Prevention of Undue Stress on Wiring Harness

The Contigo 6100 Wiring Harness connects the 6100 GPS Beacon to a vehicle's power, ground and ignition systems. Additionally, the harness provides the ability to monitor or control vehicle systems using input and output connections.

Figure 1

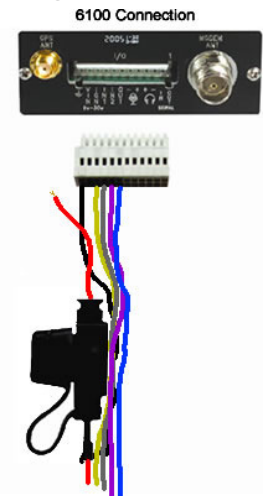
It has been reported that, very infrequently, the red power wire may become separated from the wiring harness connector that attaches the harness to the beacon. See Figure 1.

Contigo has determined that this **does not represent a safety risk** to the vehicle or its occupants. However in such an event, the beacon will lose power and cease operation. Should this occur, the **wiring harness must be repaired or replaced**.

Figure 2

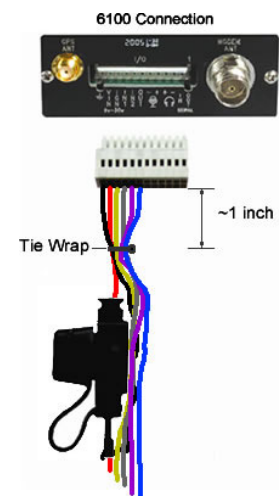
1. Contigo is updating the harness design to add a tie-wrap that gathers and secures the harness wires where they meet the connector as shown in Figure 2.
2. Contigo is modifying the harness design to reduce the gauge of the power lead wire.
3. Contigo recommends that any customer inventory of 6100 Wiring Harnesses be modified by the customer to include a tie-wrap that gathers and secures the wires approximately one (1) inch from the connector (see Figure 2).
4. Contigo recommends that installers take extra precautions to ensure that the normal installation of the wiring harness and beacon does not cause undue stress on the wires where they meet the connector (see Figure 3 and Figure 4 below).

Figure 3

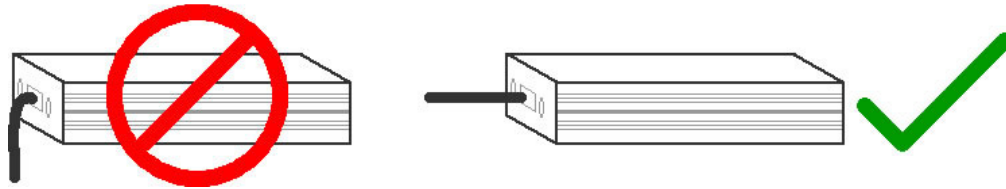
Ensure that the Beacon and Wiring Harness are installed without bending or flexing the wiring harness to cause undue stress on the wires as they enter the connector, as shown in Figure 3 below.

Figure 5

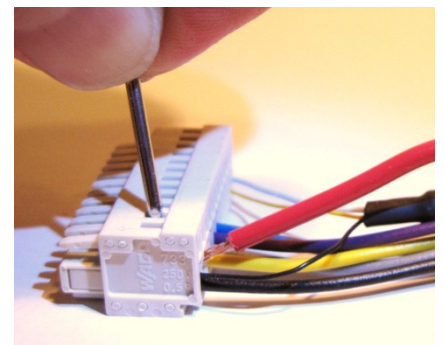
1. Disconnect the red power wire from its vehicle power source.
2. Remove the wiring harness connector from the beacon.
3. Strip the separated red power lead to expose at least ¼" (5-6mm) and ensure the wires are tightly bunched.
4. Locate the receptacle into which the red power wire must be inserted (PIN 11).
5. Insert a thin tool into the correct receptacle, as shown in Figure 5, and press down firmly on the tool to release the wire clamp. Ensure any debris or wire is removed from the wire receptacle.

6. Insert the red power wire into the receptacle and remove the tool. Ensure the wire is firmly seated within the connector.
7. Reconnect the red power wire to the vehicle power source.
8. Insert the wiring harness connector into the beacon, and test the beacon.
9. Carefully gather the wires together approximately 1 inch from the connector and add a tie-wrap that firmly bundles the harness and prevents the wires from moving independently of one another.
